HINCKLEY NATIONAL RAIL FREIGHT INTERCHANGE

SoCG between the Applicant and Blaby District Council

Document reference: 19.1

Statement of Common Ground between Tritax Symmetry (Hinckley) Limited and Blaby District Council

BRIDLEWAY UNDERPASS LONGSECTION SCALE: H 1:200,V 1:200. DATUM: 95.000 (TAKEN ALONG BRIDLEWAY CENTRLINE ALIGNMENT)

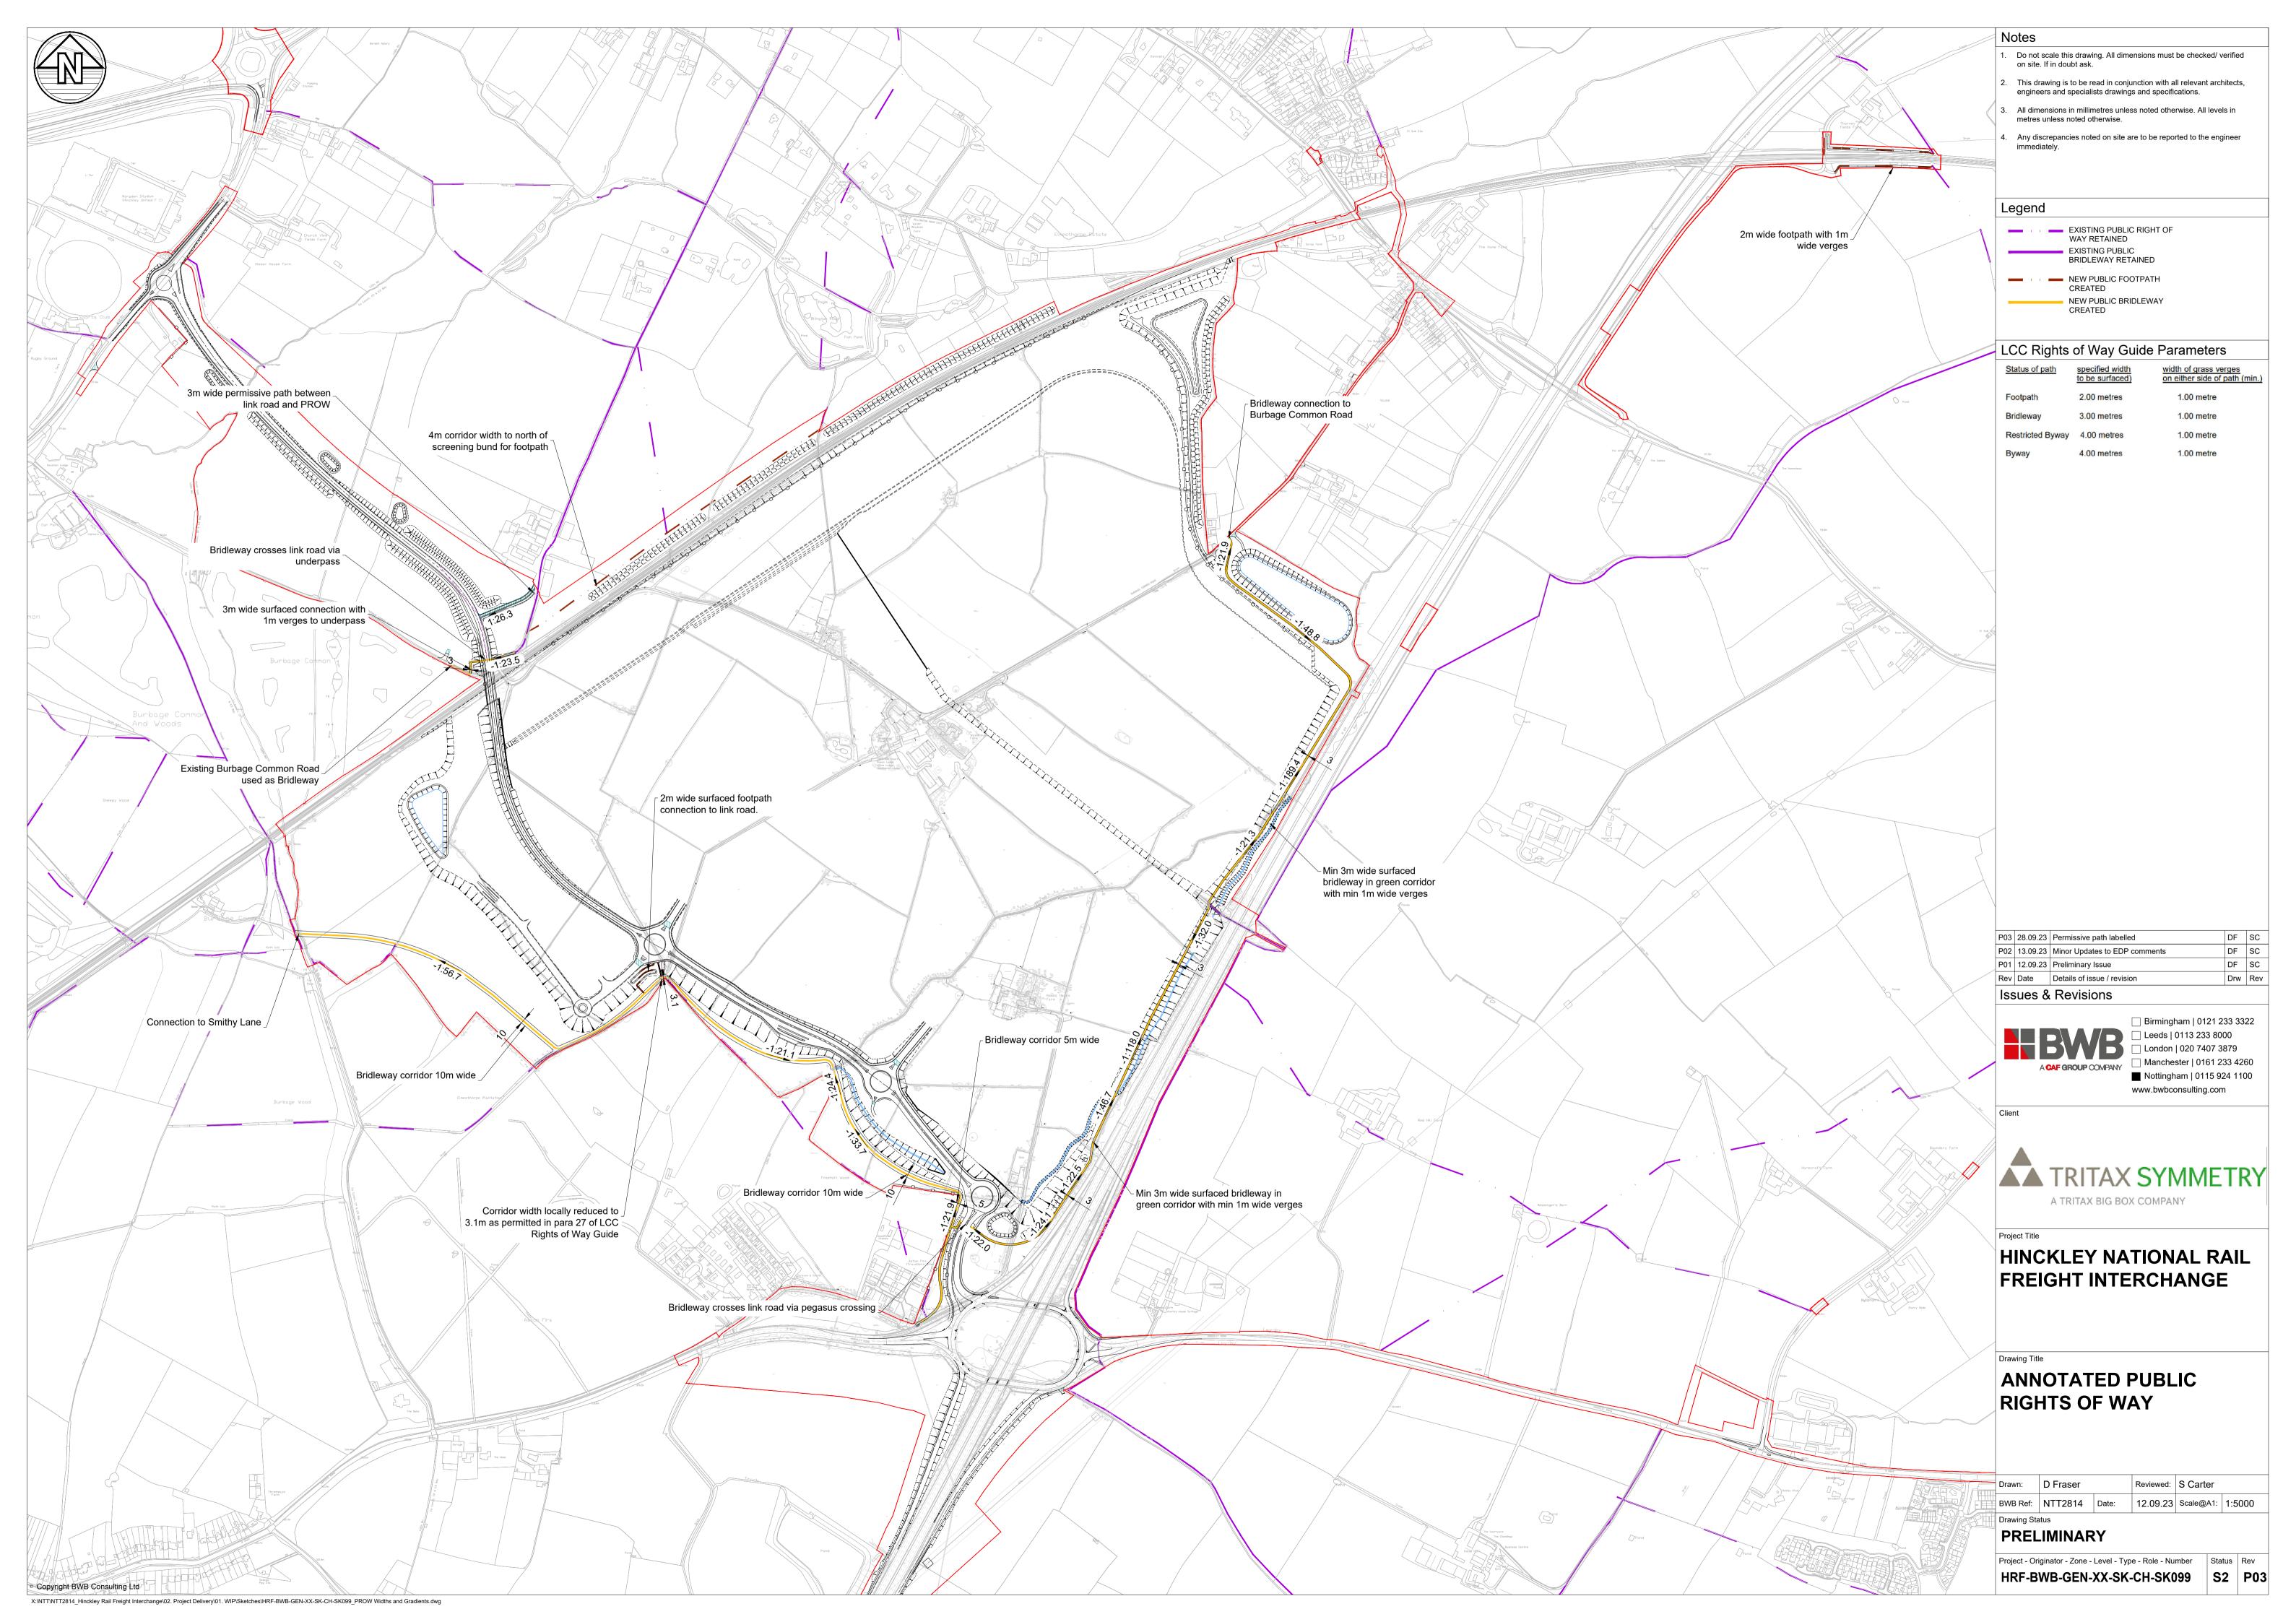
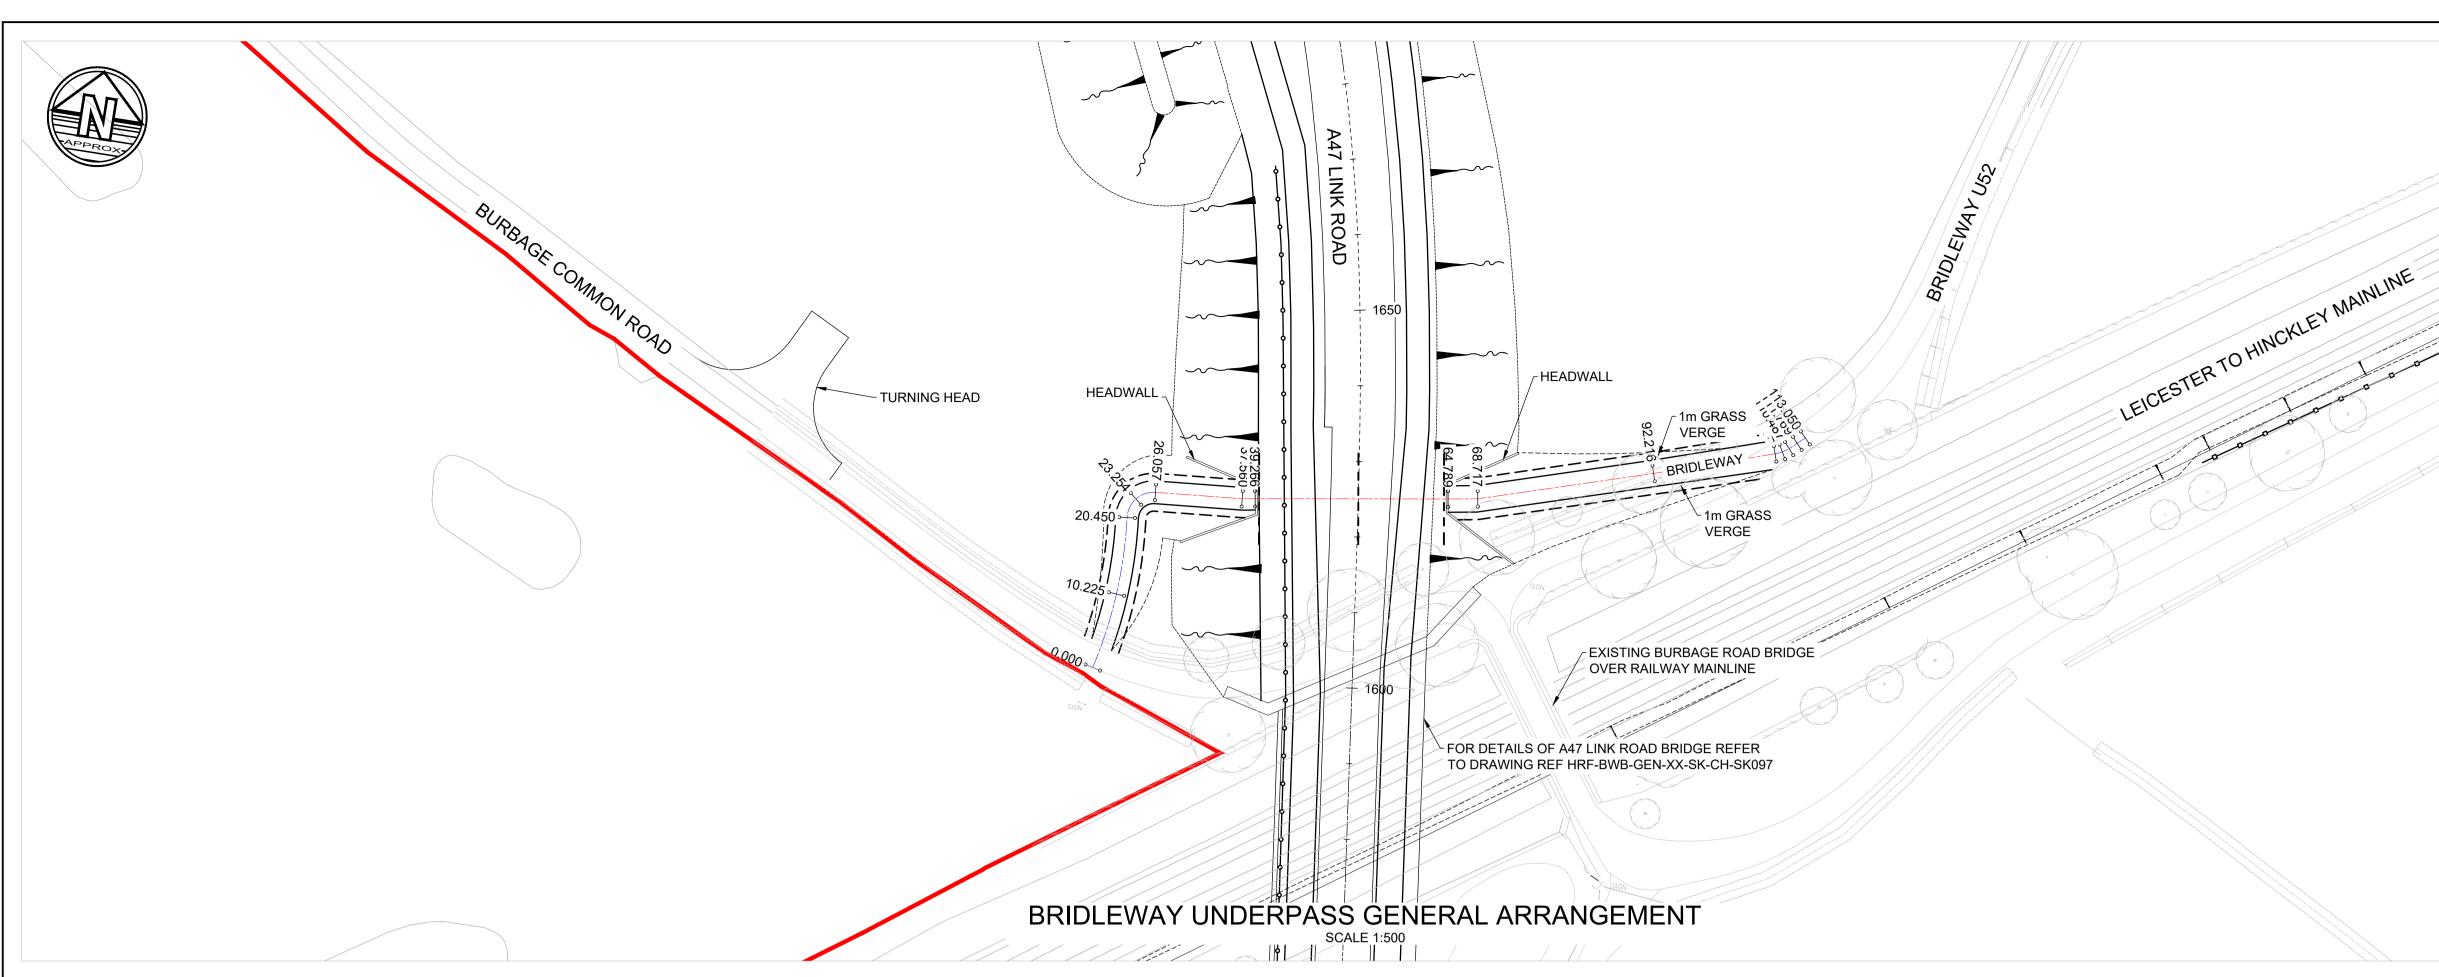
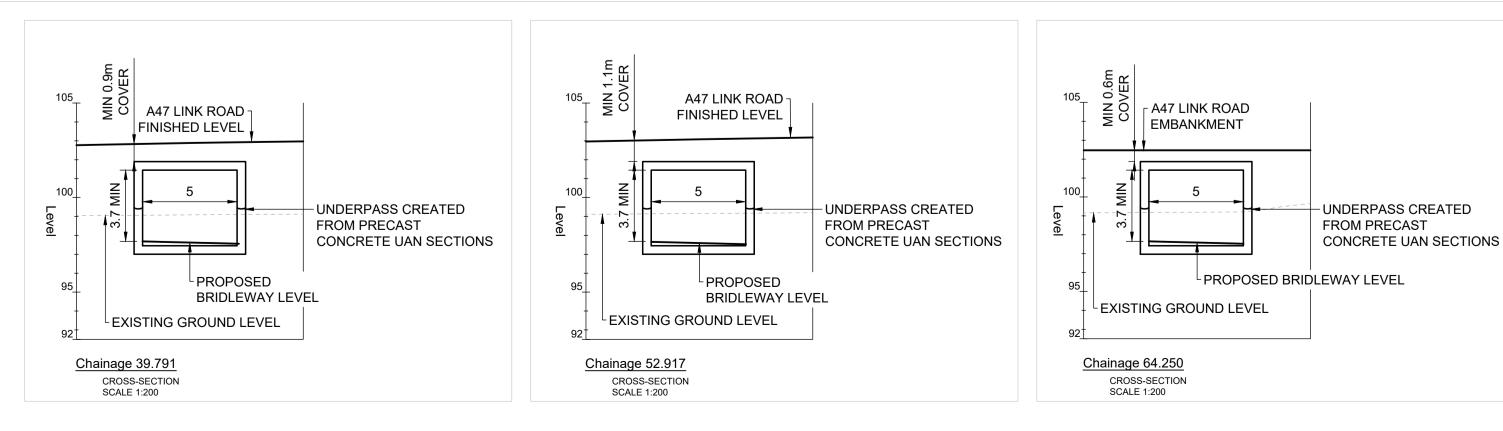
<u>U8- Outwoods</u> No details of proposed structure provided. Who will adopt the structure and be responsible for its ongoing maintenance (NR have said in their RR they will not). This is not something that LCC will consider adopting.	Work is ongoing with Network Rail to determine the design of the bridge; the bridge however will be to a Network Rail specification. The relevant representation made by Network Rail suggesting that LCC Highways take on the bridge is acknowledged however it is expected that this would be a	Thank you for the confirmation. We assume that the bridge design parameters will be set out in a requirement, and Network Rail's future responsibilities will be covered in the DCO? Please can you clarify.	4(2)a covers the matter of Detailed Design Approval for rail infrastructure, Network Rail are currently engaged on the design of this bridge. Network Rails future responsibilities will be covered by Network Rail's Network Licence.

Question deliverability noting	Network Rail asset and this point	
restricted access route and	has been reported to Network	
limited red line boundary.	Rail. Details of the deliverability	
	of this bridge is contained at	
	Appendix 1.1 of the CEMP	
	submitted as part of the DCO	
	application.
